NOTICE TO CONTRACTOR
APPROVED
09/29/2022
Harnett COUNTY NORTH CAROLINA

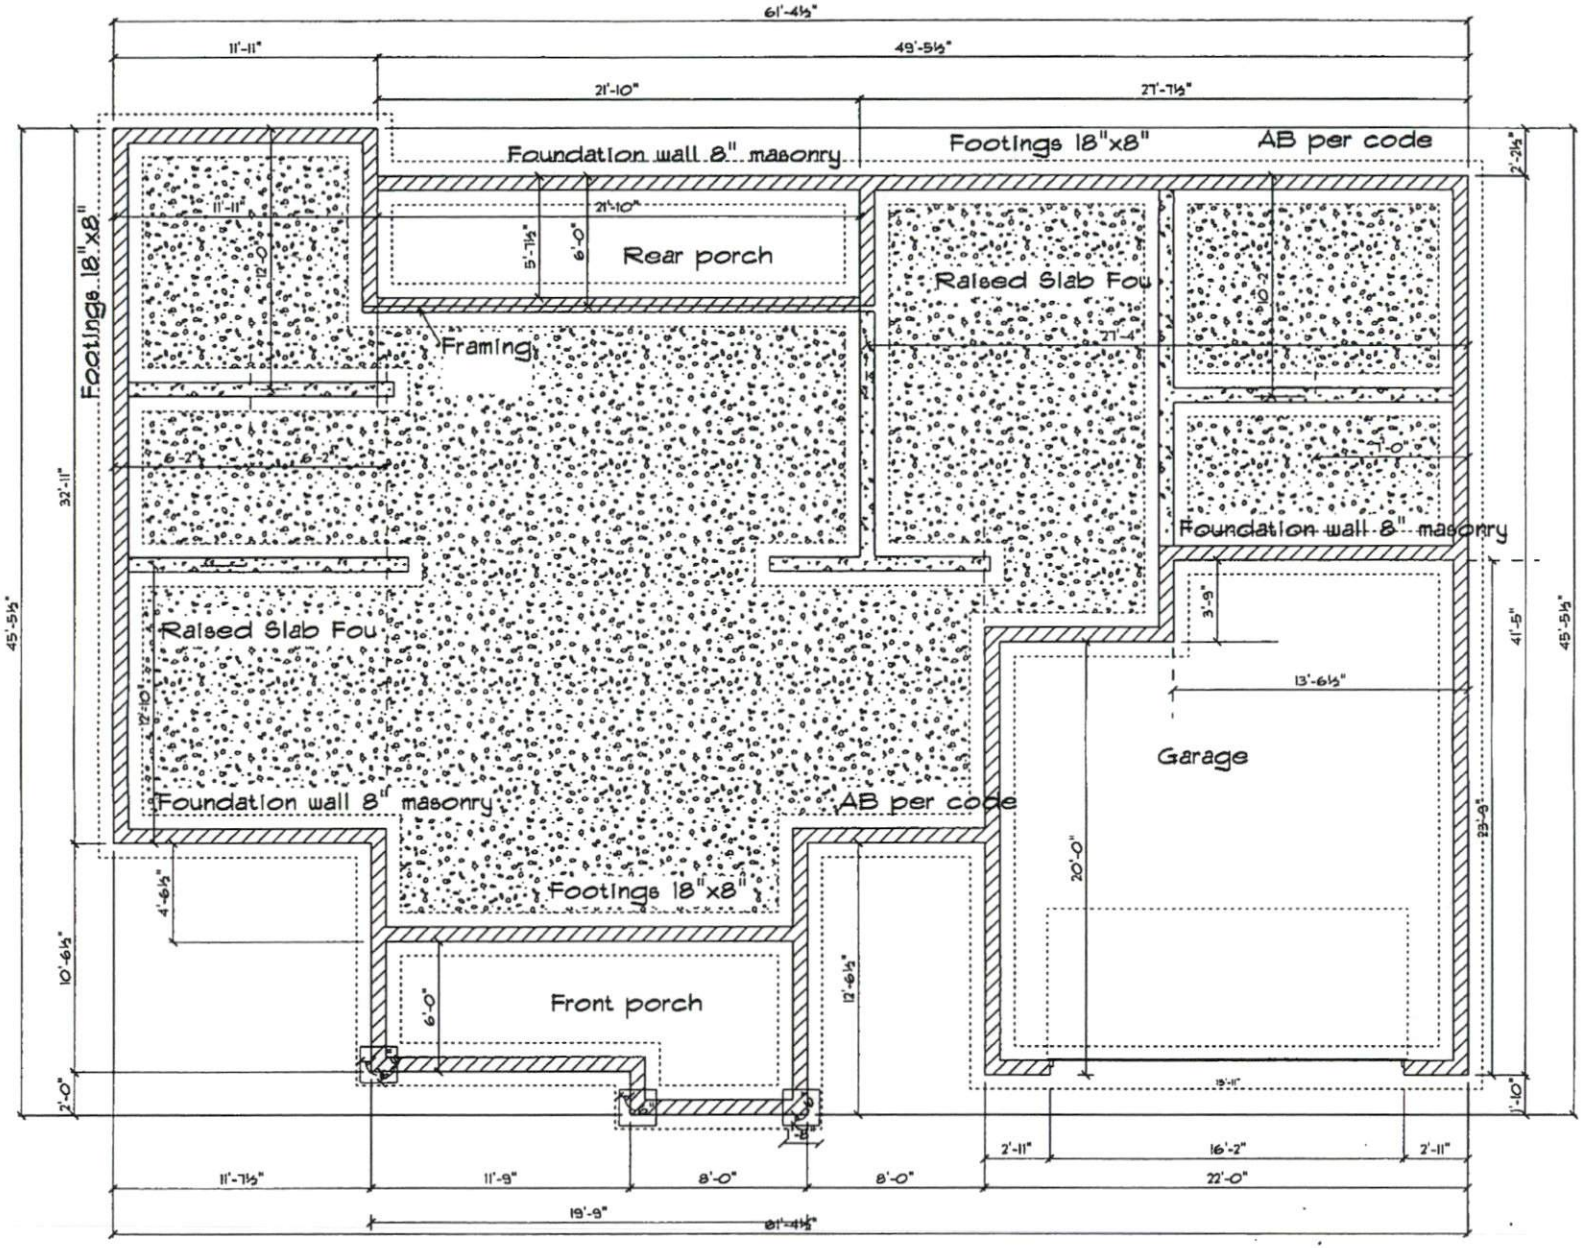
Max span 21'8"
between support face

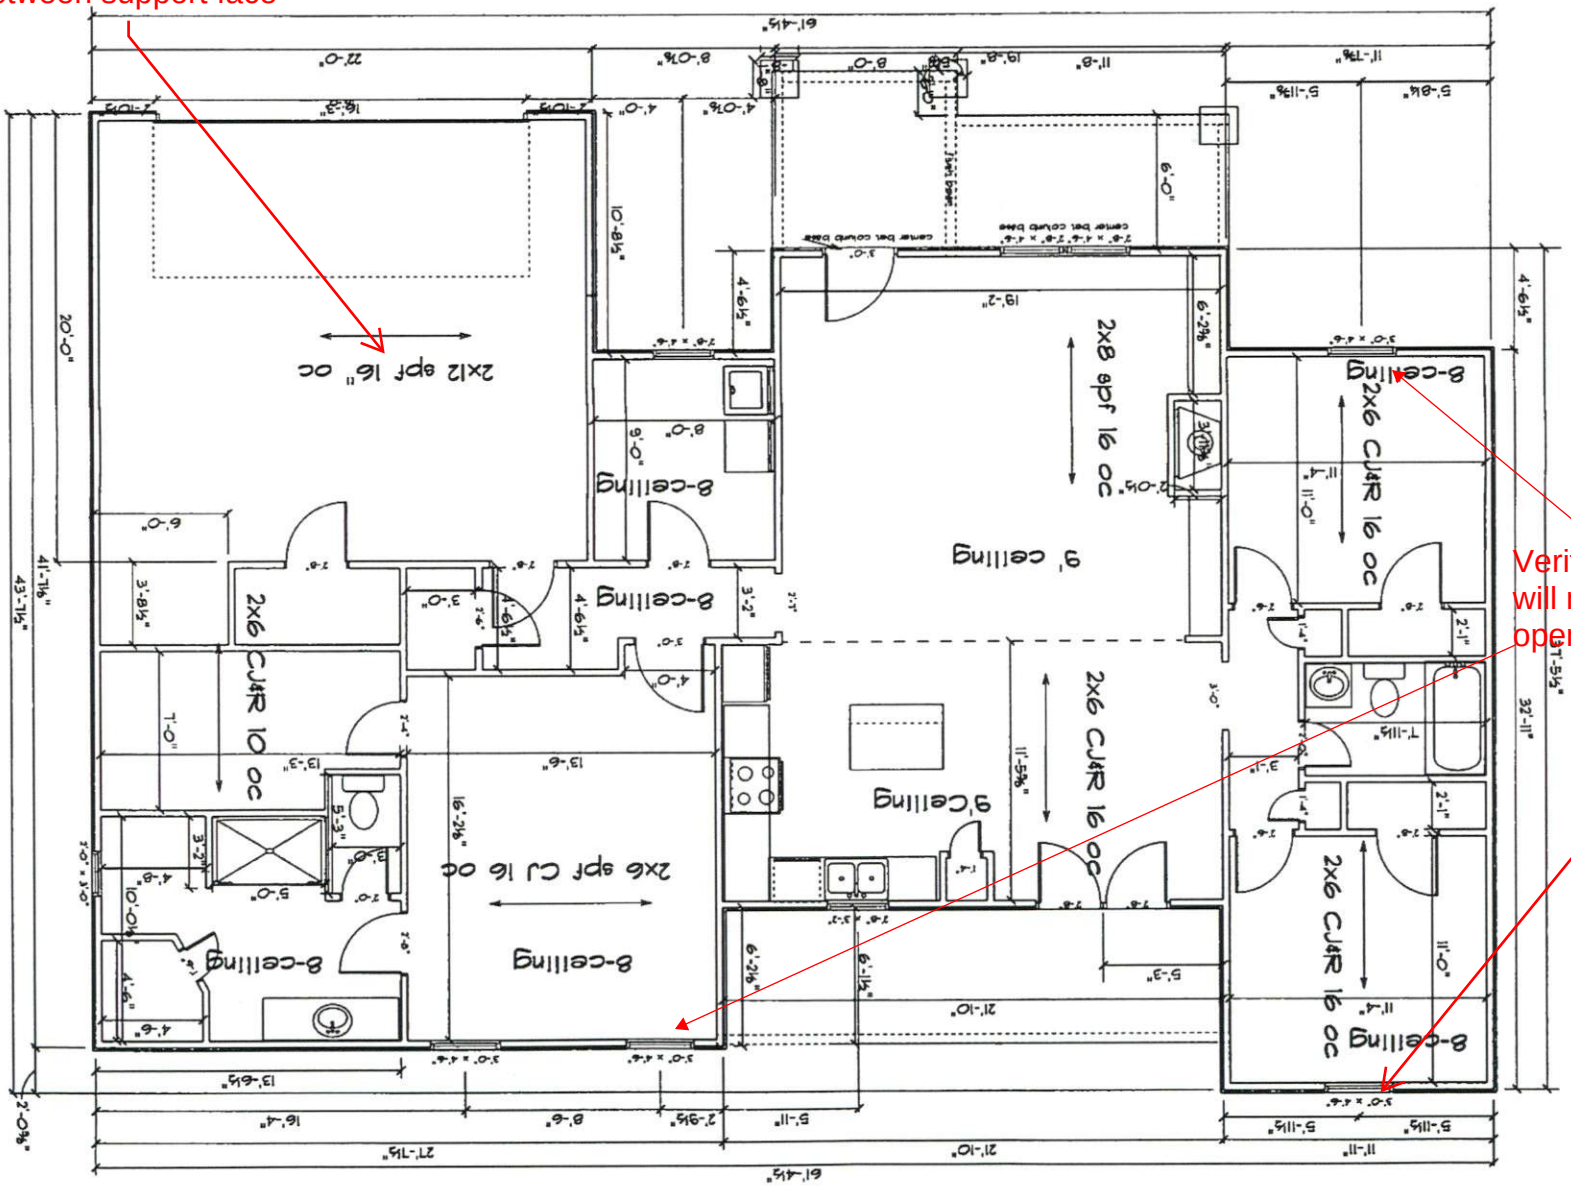
Verify these windows
will meet egress
opening height
